# Modifications to the Draft EIS/EIR

This chapter of the document addresses modifications to the Draft EIS/EIR for the Berths 212-224 (YTI) Container Terminal Improvements Project. It presents all revisions related to public comments, as determined necessary by the lead agencies.

## 3.2 Changes to the Draft EIS/EIR

Figure 3.8-1  
 Previous Soil and Groundwater Investigation Locations  
 Port of Los Angeles Berths 212-224 [YTI] Container Terminal Improvements Project

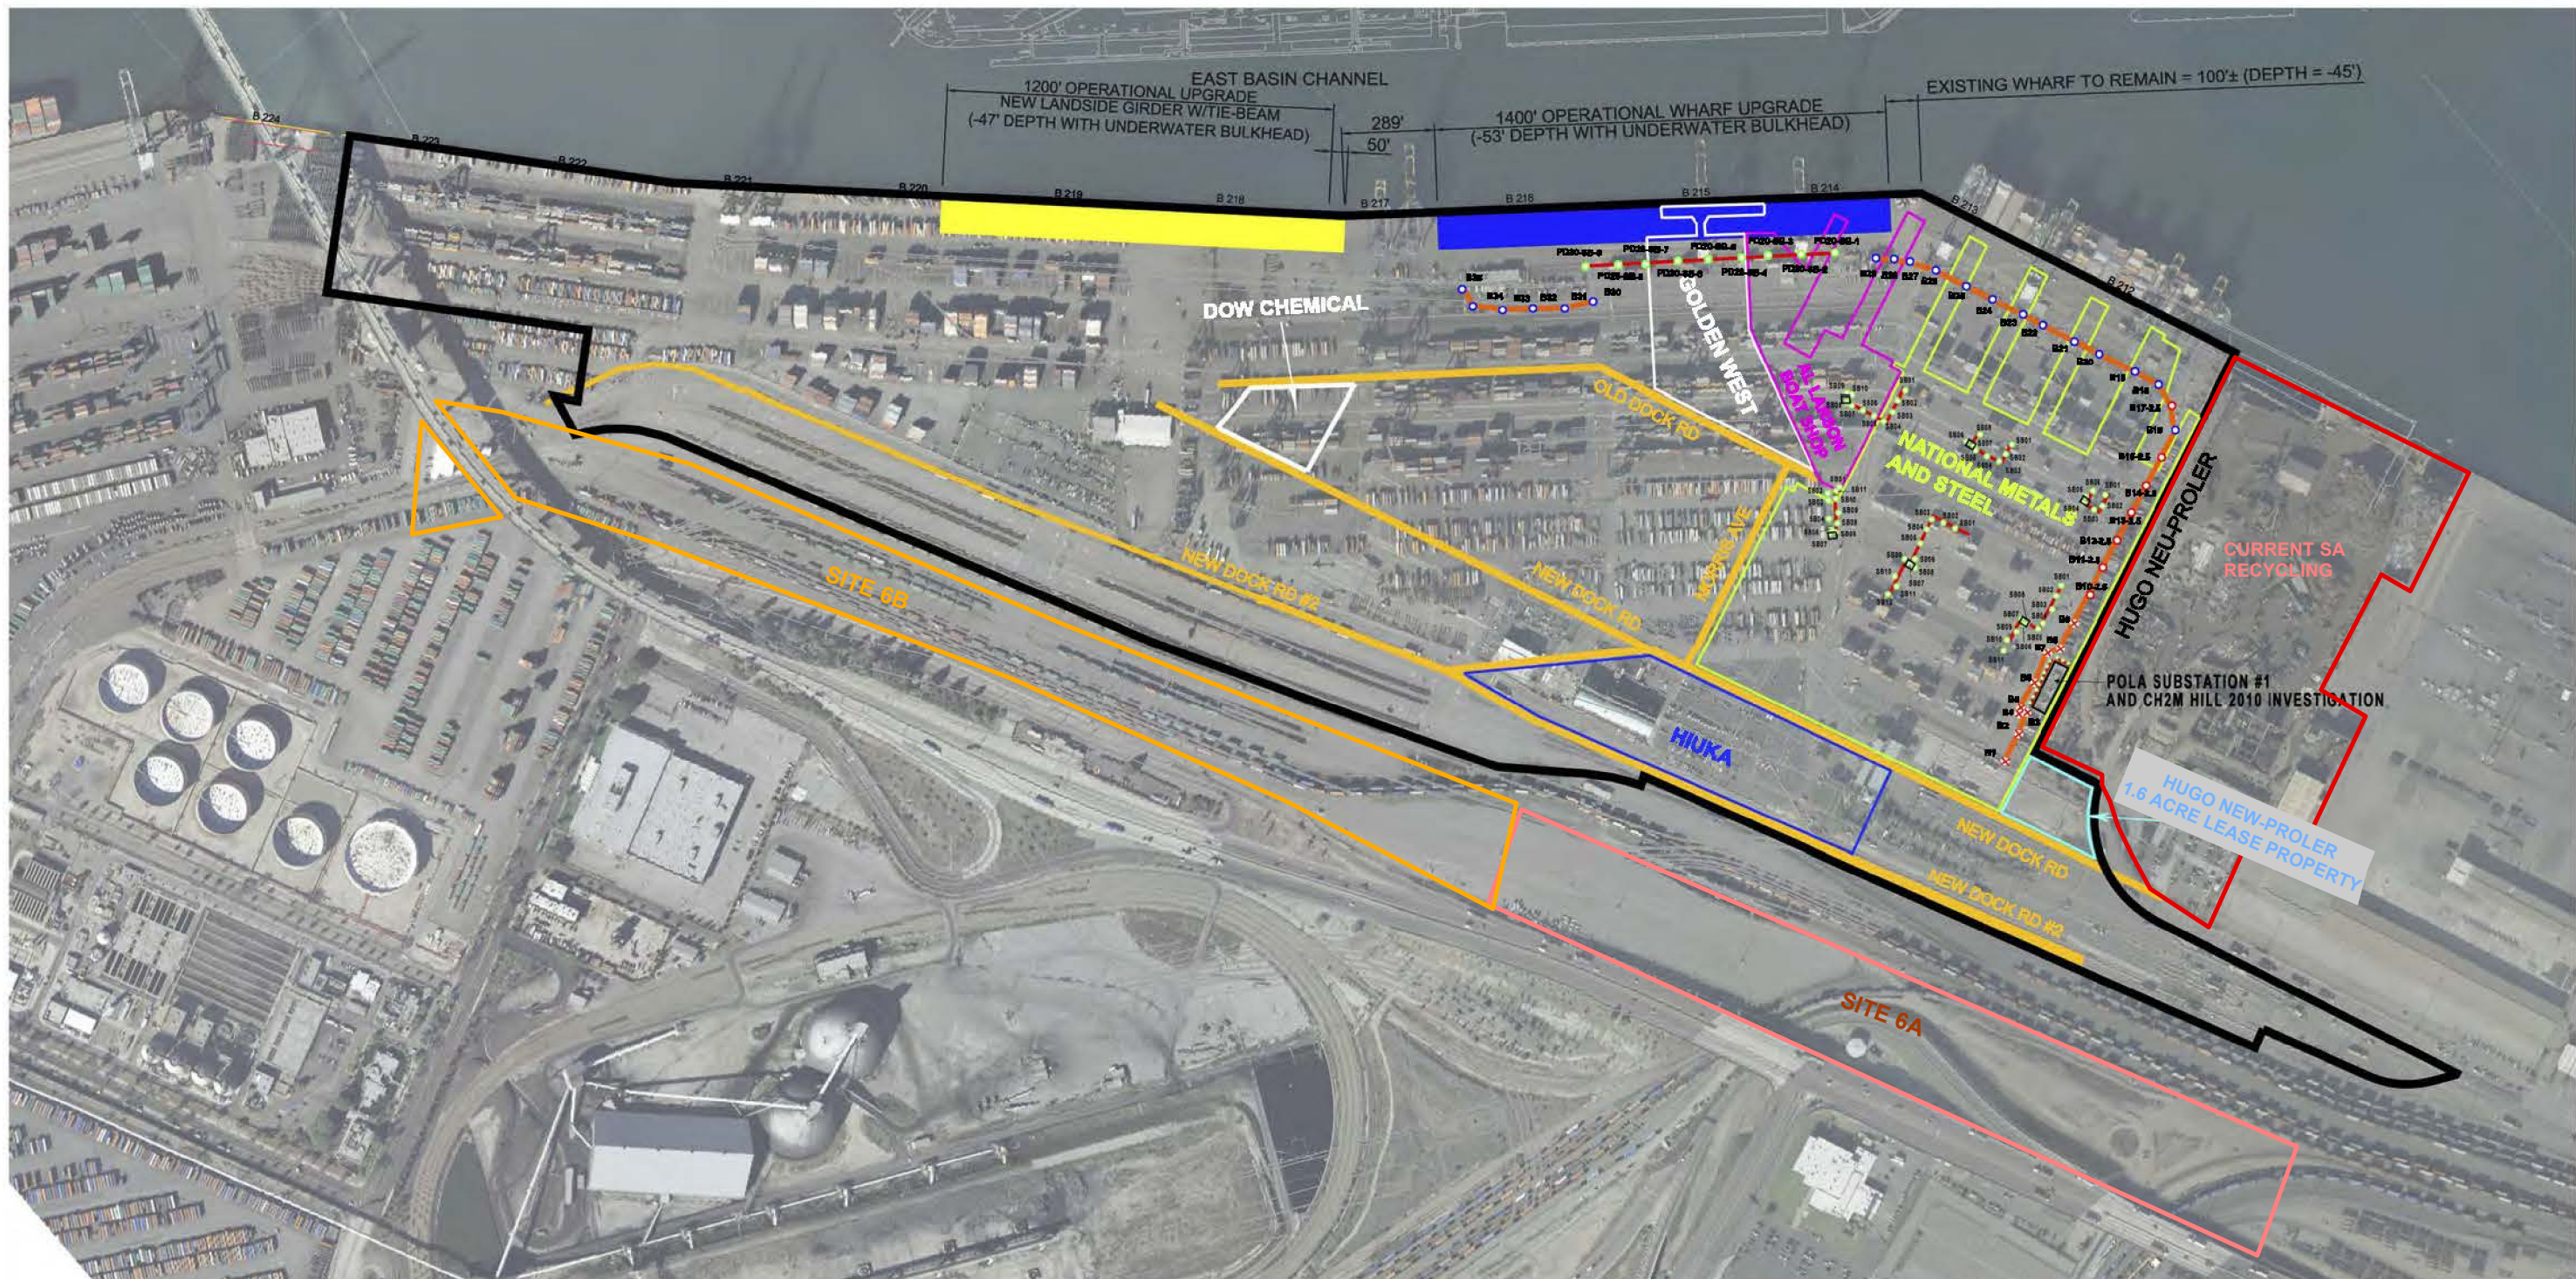
12 Figure 3.8-1, Previous Soil and Groundwater Investigation Locations, contained some  
 13 errors and required some additional information to be added for clarification.  
 14 Figure 3.8-1 has been modified and is included as a modification within this Final  
 15 EIS/EIR following this page.

**Figure 4-1**  
**Related and Cumulative Projects**  
**Berths 212-224 [YTI] Container Terminal Improvements Project**

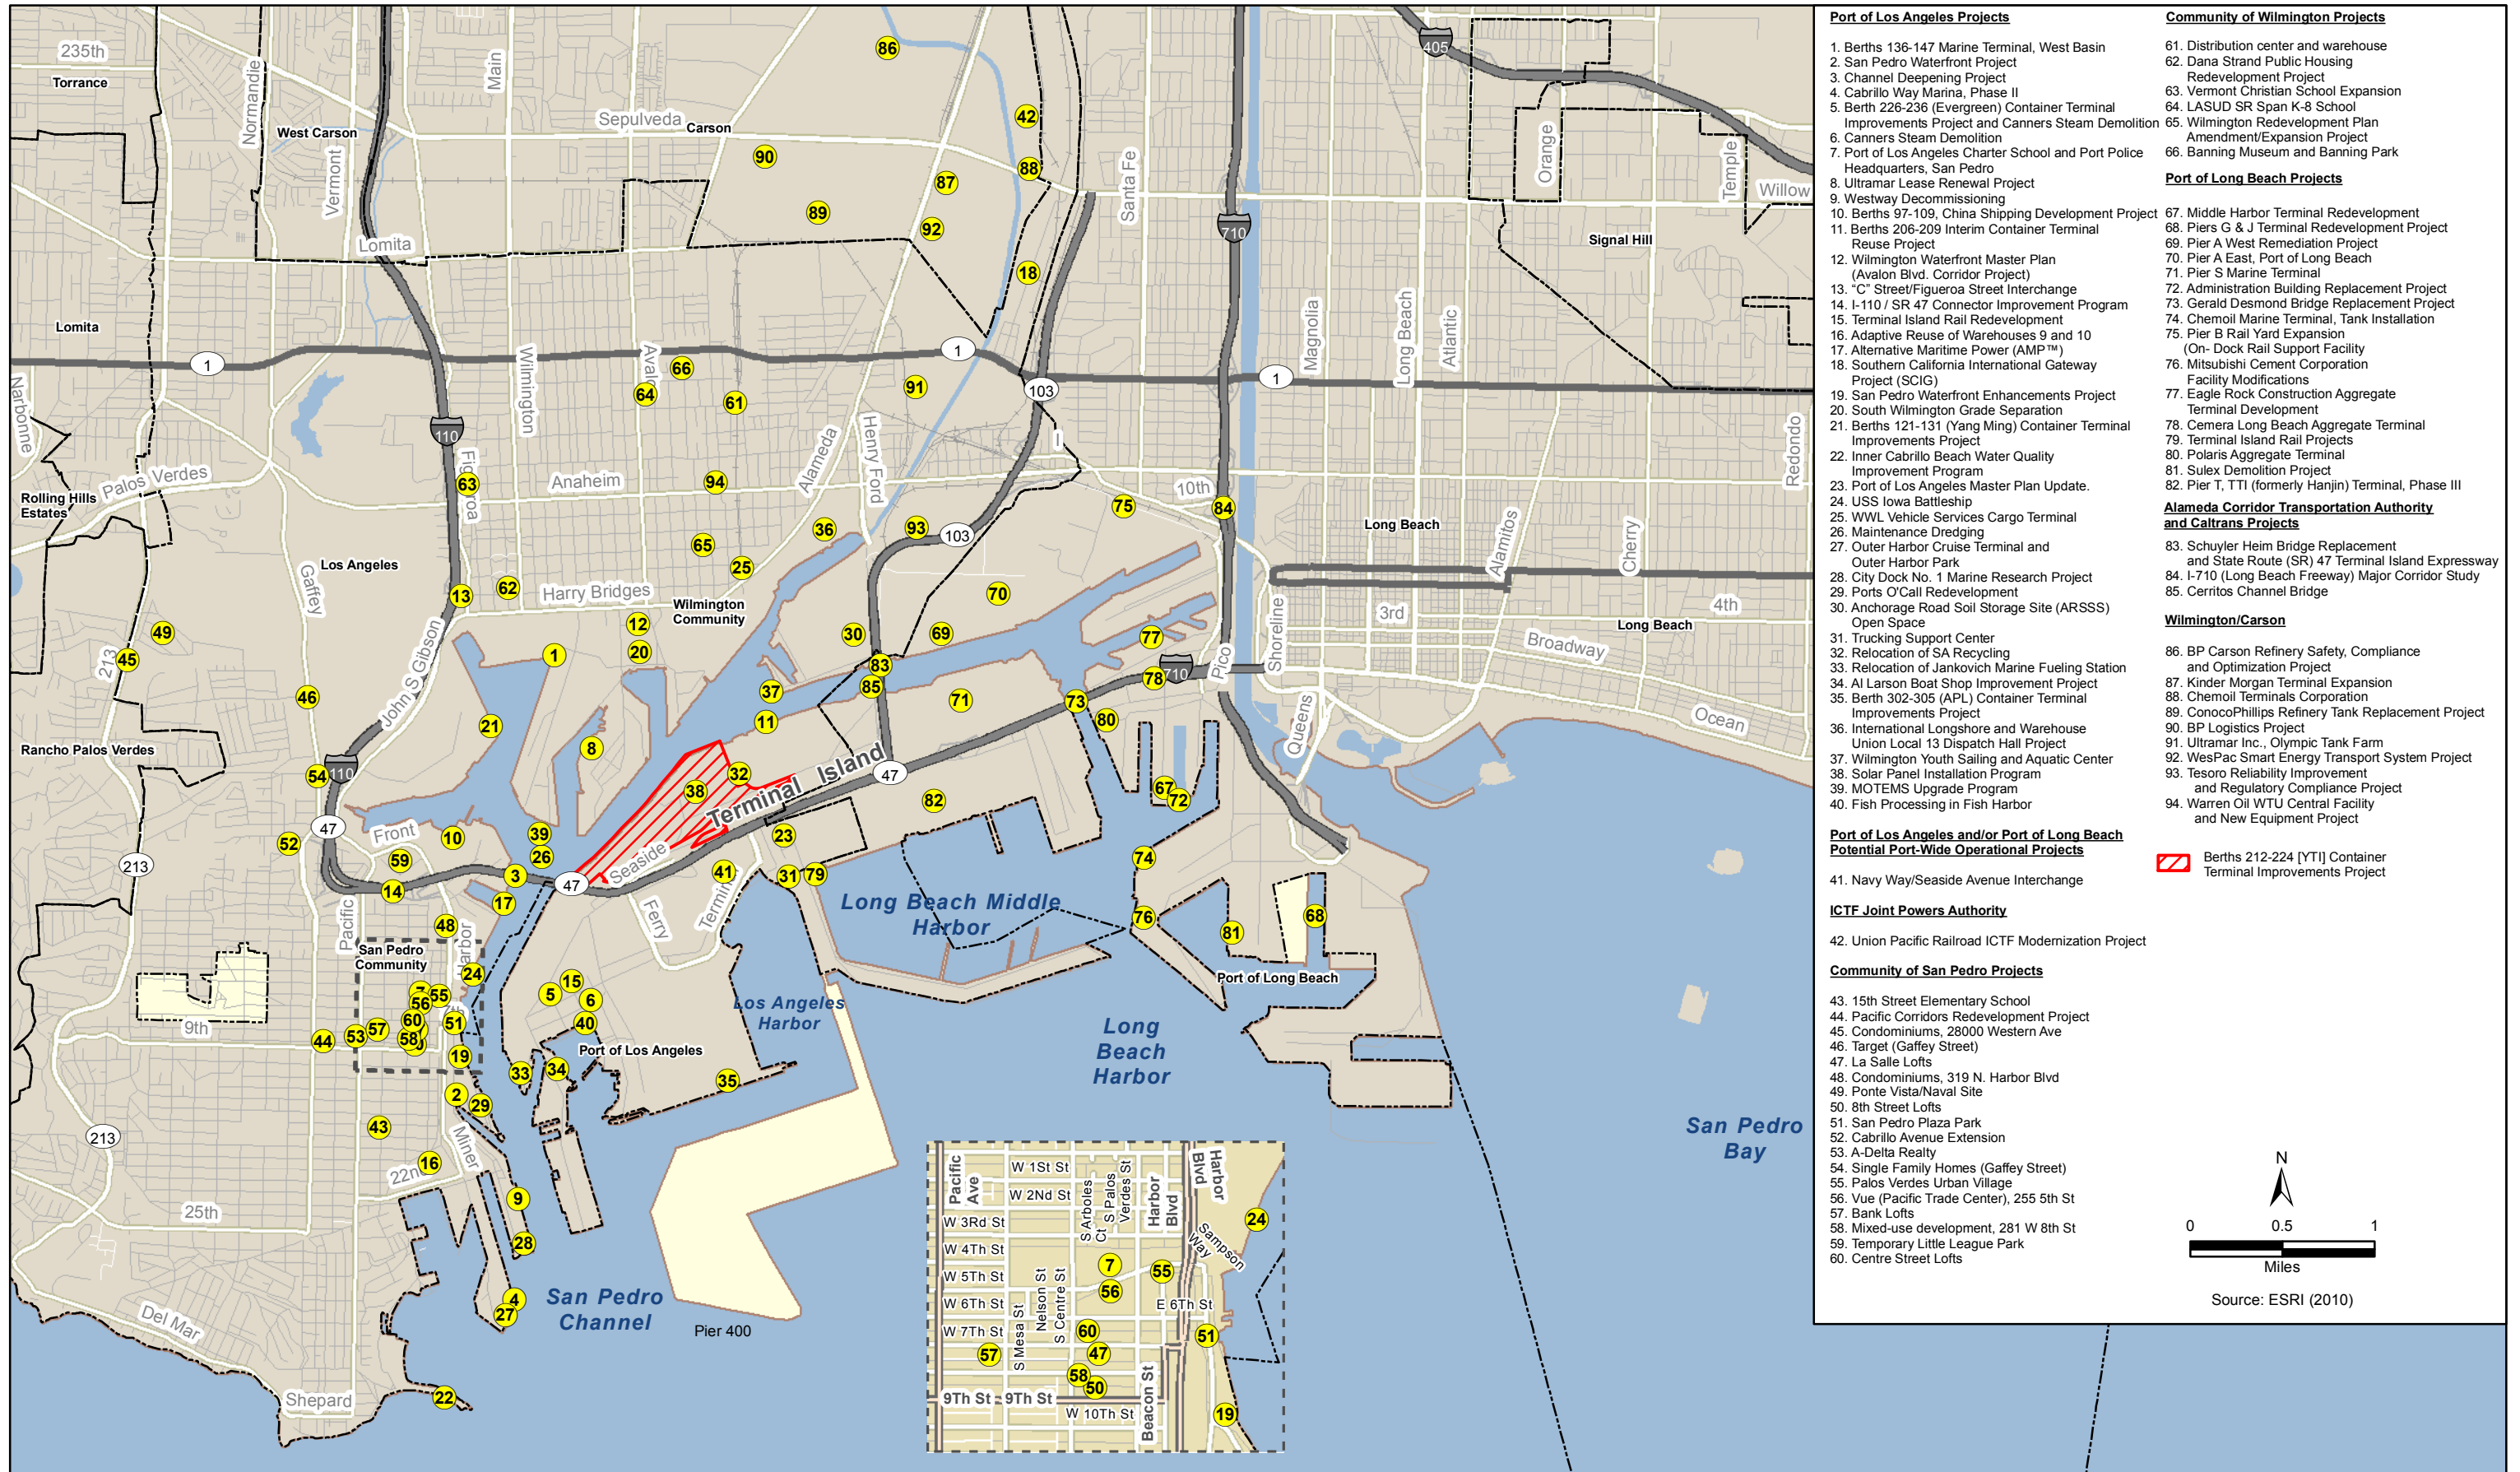
Figure 4-1, Related and Cumulative Projects, contained some errors on the location of the respective projects. Figure 4-1 has been modified to show the appropriate locations of the projects, and is included as a modification within this Final EIS/EIR following this page.
